City of Rochester  
Aqueduct Reimagined Project  
Public Workshop #3  
Broad Street Bridge  
Sunday, October 2<sup>nd</sup>  
1 PM – 5 PM

## SUMMARY OF WORKSHOP

#### Concept D

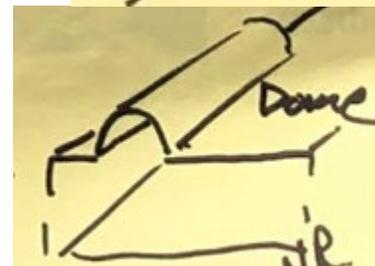
- Ethan likes D
- Cool
- D or E for sure!
- D with walkable upper deck! Please keep the arches!
- Love this. Best of all wishes!

### **Board #14 & 15: Concept A – Aqueduct Uncovered (High-level renderings of Concept A and space to provide feedback)**

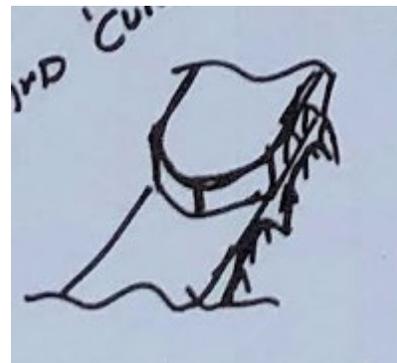
- More green spaces <3
- Ties to historic subway
- No sense of space; losing arches / original design
  - o Yes

- Use during bad weather (+3)
- More greenery! Space for more art and graffiti culture
- A completely uncovered space is only useable a few weeks a year. This is Rochester!

- More trees! Street is hot in the summer (+2)
- Removes all the historic features that make the space specific to Rochester
- Please don't remove the top arches!

## **Board #24: Evaluation Matrix Summary (Application of Evaluation Criteria to all five Concept Studies)**

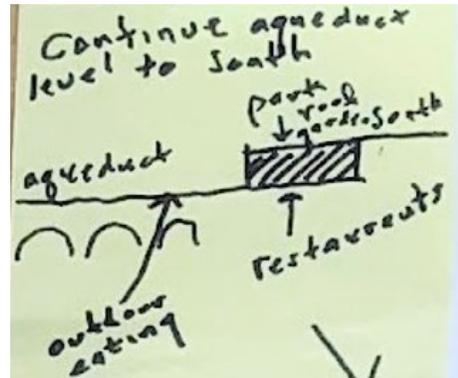
- This!
- Very very very important

### **Board #27: North West Promenade Connection (Renderings of promenade connection by Aqueduct Building)**

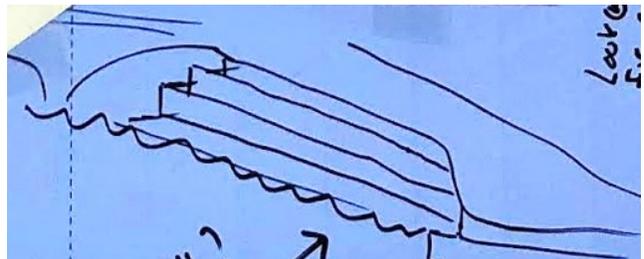
- What restaurants? It'd be really cool if the city can get restaurant space. It needs to be interesting to make it work.
